HARTMAN & ASSOCIATES, INC.

**Subject: Request for Supplemental Information, dated June 29, 2001
Sid Larkin & Son, Inc.
Enterprise Recycling and Disposal Facility, Class III Landfill
Pasco County, Florida
Pending Permit Numbers 177982-001-SC and 177982-002-SO**

Kim Ford's Review Comments

TABLE 1 - REVISED
PROPOSED ENTERPRISE RECYCLING AND DISPOSAL FACILITY
DADE CITY, FLORIDA
CALCULATED DILUTION OF POTENTIAL POLLUTANTS

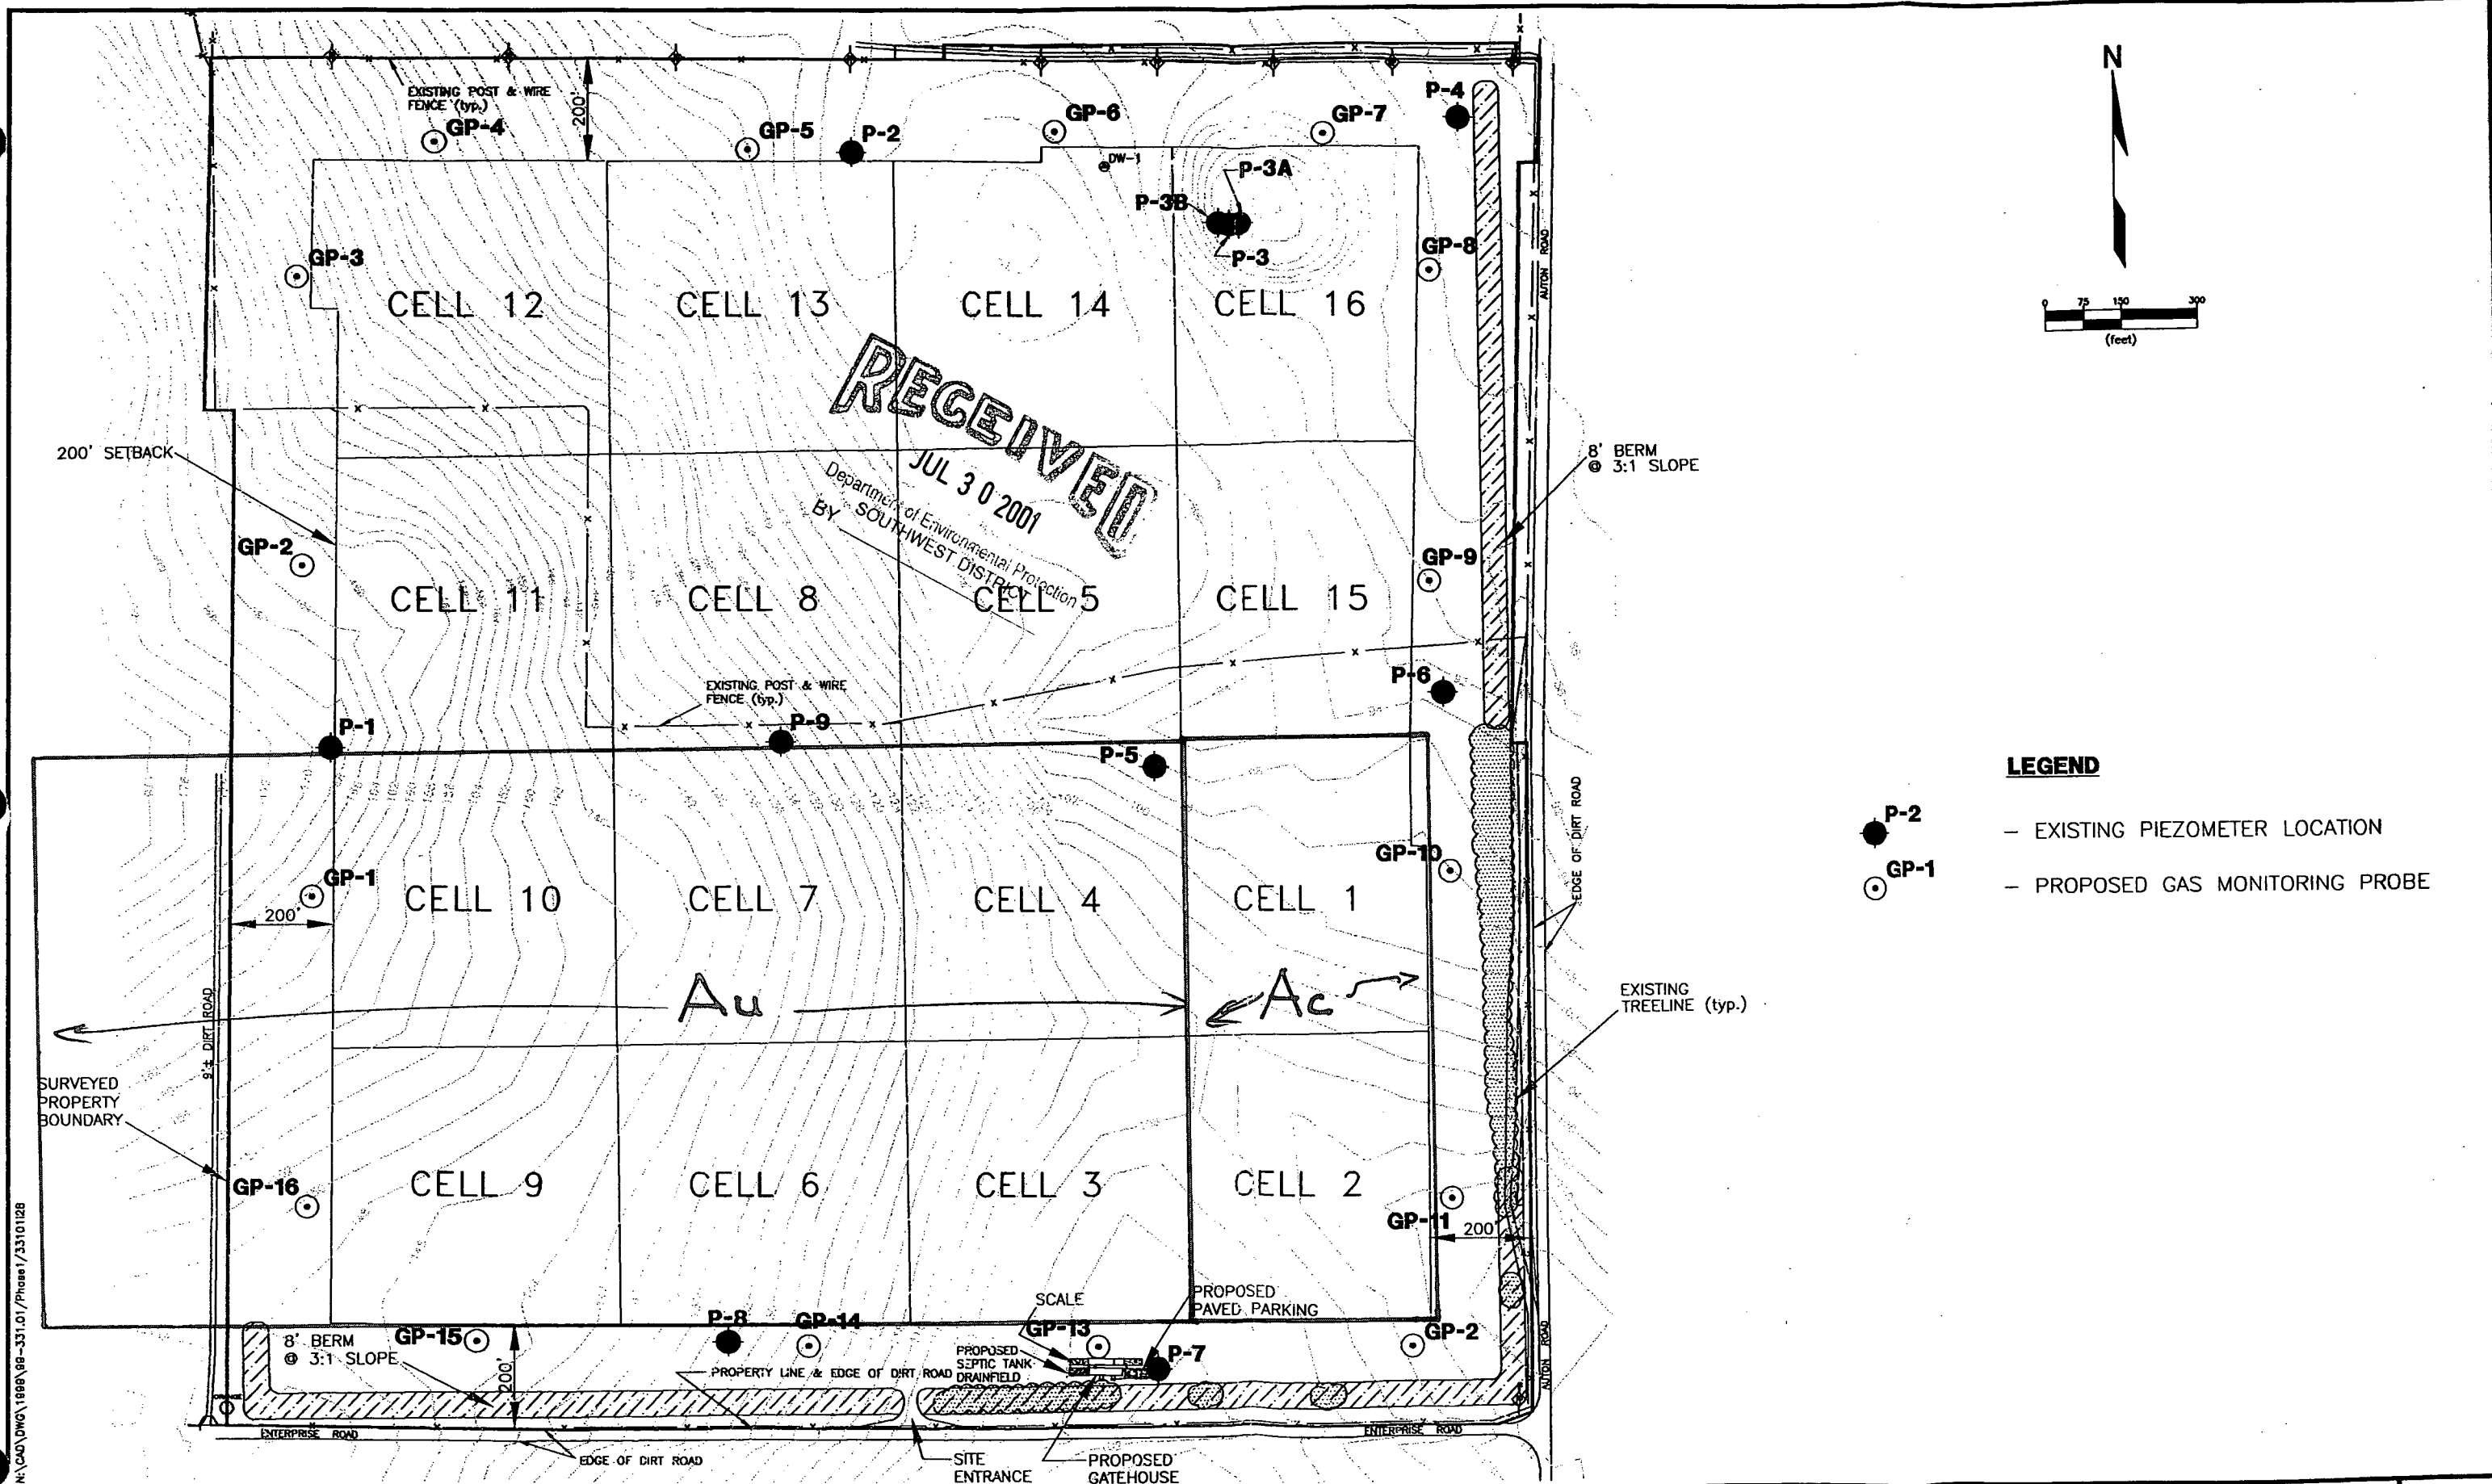
Comment 1d: It is understood that the area of the region upgradient of Cells 1 and 2 that contribute ground water (A_u) was based on topography from quadrangle maps for the vicinity of the subject property. Documentation of the area upgradient of Cells 1 and 2 was not included in the submittal for review.

Comment 1g: The assumption that all potential pollutants are not present in background (C_b) is not considered to be valid. The attached table presents water quality data for surficial aquifer wells located within 50 miles of Dade City that are considered to be more representative of background conditions.

See attached map to document area (A_u) used for calculations upgradient of Cells 1 and 2.

Our initial permit submittal included representative background water quality for the surficial and Floridan aquifer in Pasco County, see Appendix 5-H. It is obvious that many of the surficial aquifer wells included on your 50 mile radius list have been impacted by pollution sources. We acknowledge that the upgradient surface and groundwater may not be free from all contaminants, but for the past 75 years the site and uphill areas have only been used for agricultural uses such as orange groves or cattle grazing, not considered significant pollution sources. Basically, the results of our dilution equation can be considered concentrations above background concentrations.

5/2000
USGS/STORMWIND

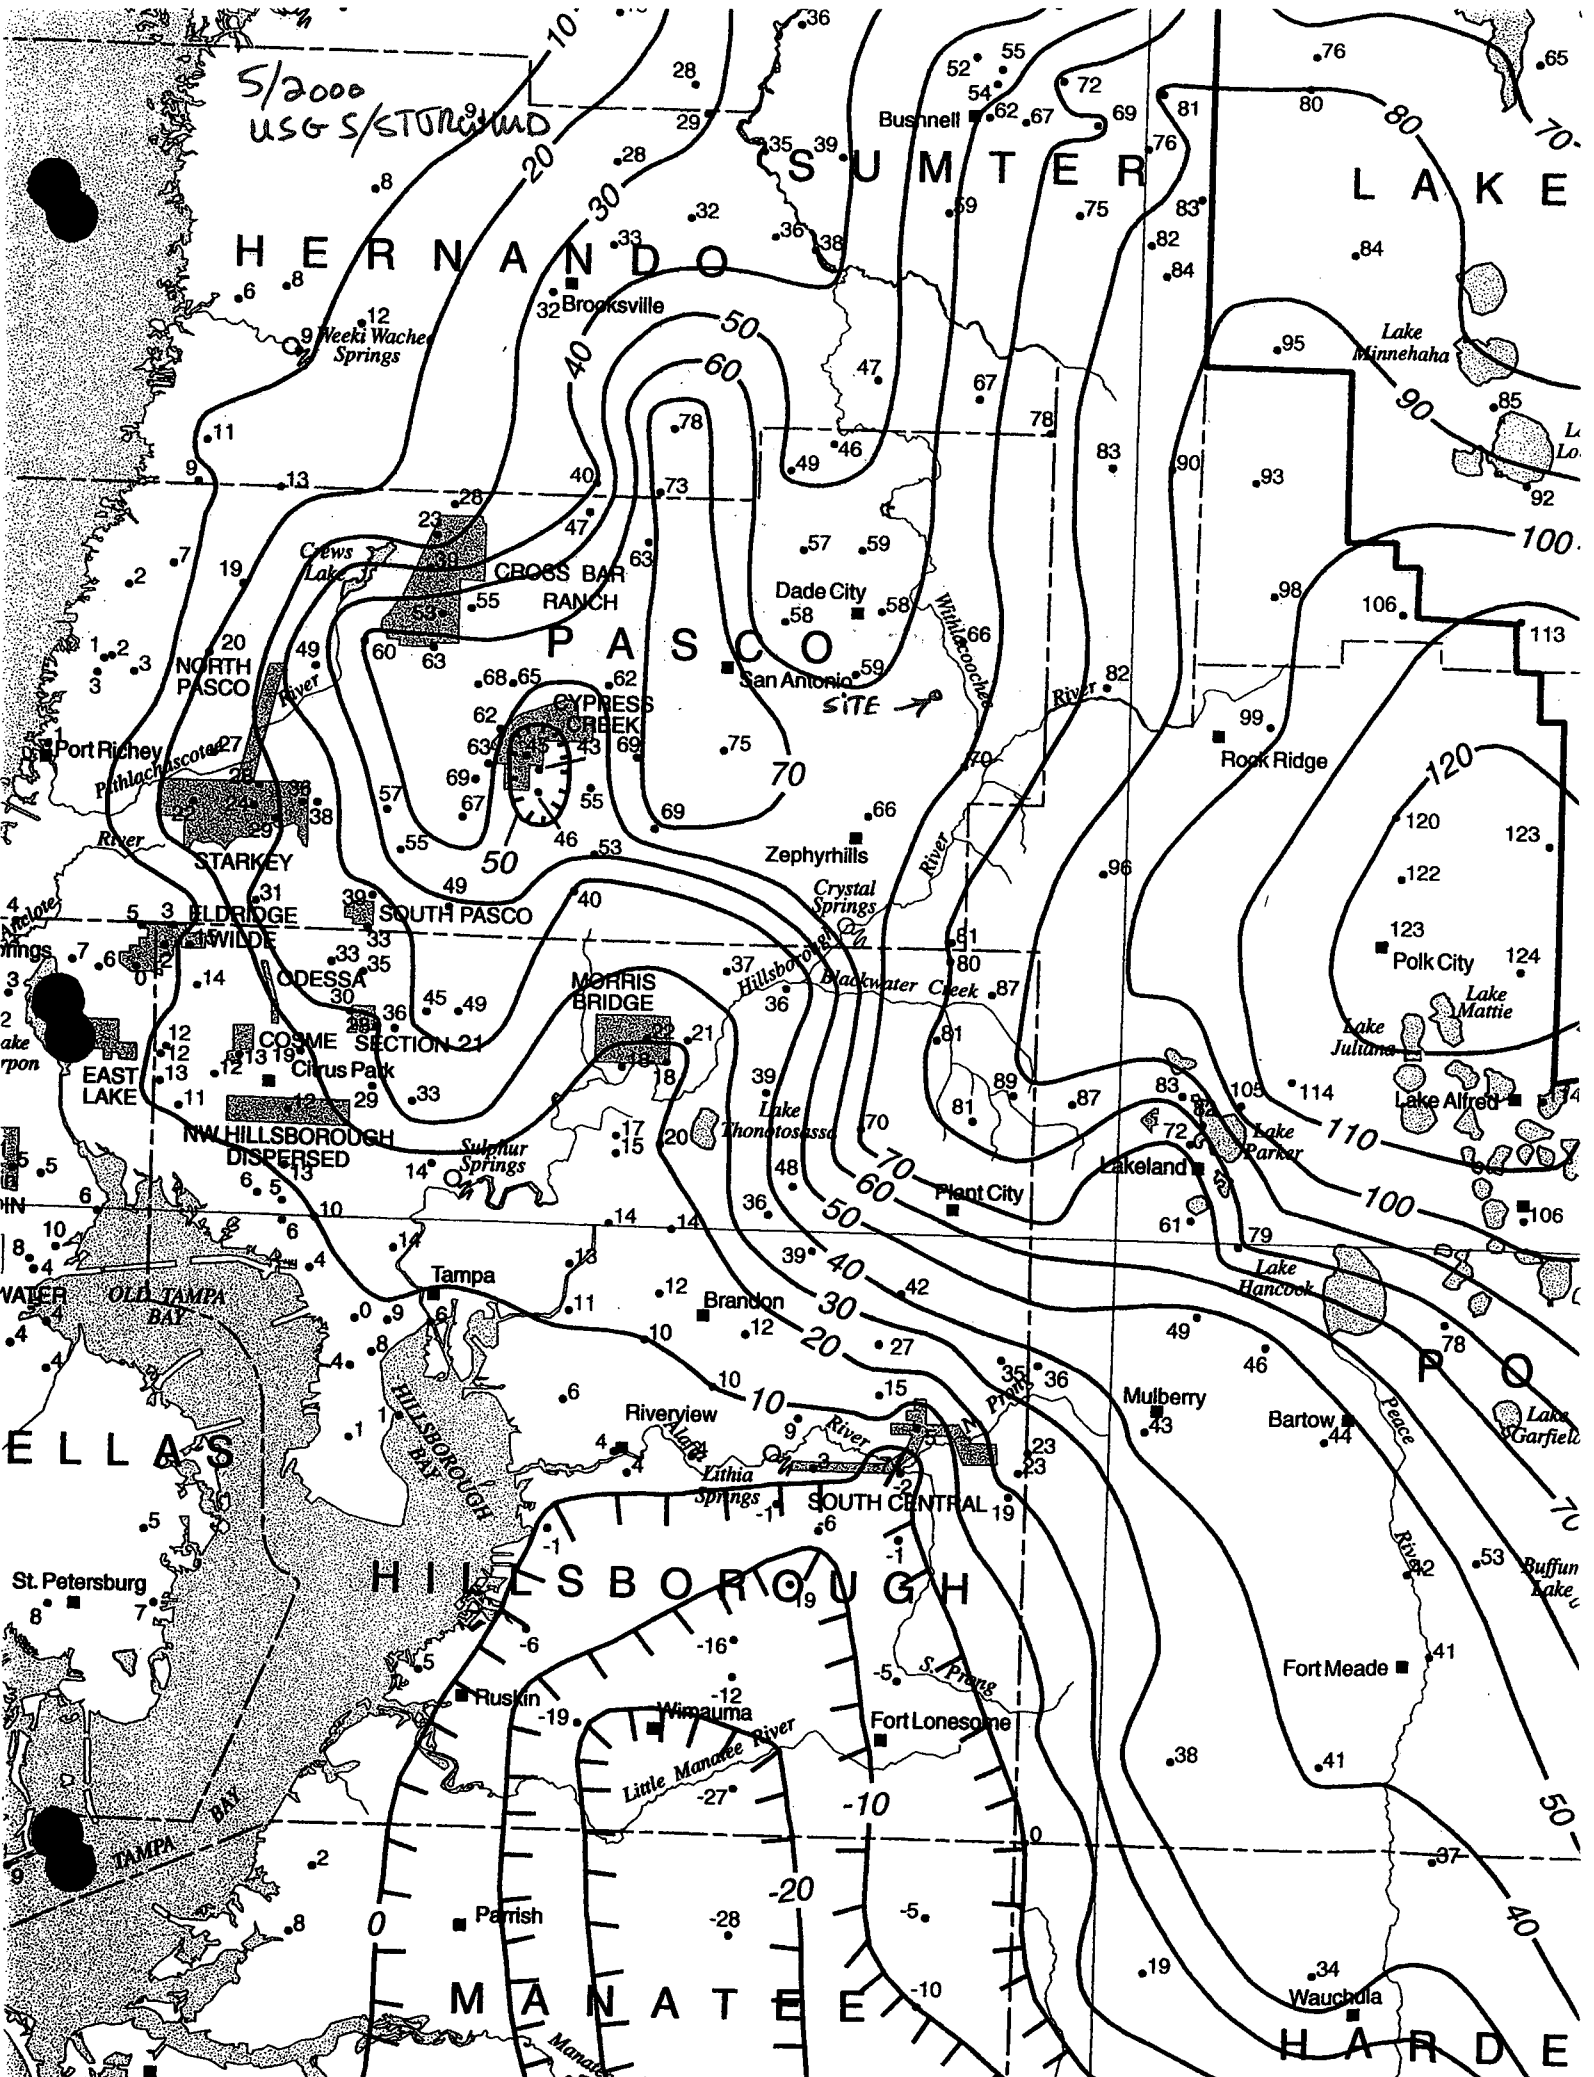
Comment 3. viii. The discussion provided in Submittal 3, regarding anomalous ground water elevations at P-11 is noted. It is also noted that the potentiometric surface contour map provided for water levels measured on May 8, 2001 (Submittal 3, Figure 14.2) incorrectly includes the ground water elevation at P-3A. Revision of Figure 14.2 to exclude data from P-3A will cause substantial changes to the direction of ground water flow.

Response: As correctly suggested, we have excluded the P-3A water level data from Figure 14.2, see the attached revised Figure. This has shifted the Floridan's groundwater flow to the north-northeast, the historically predominant flow direction in the area.
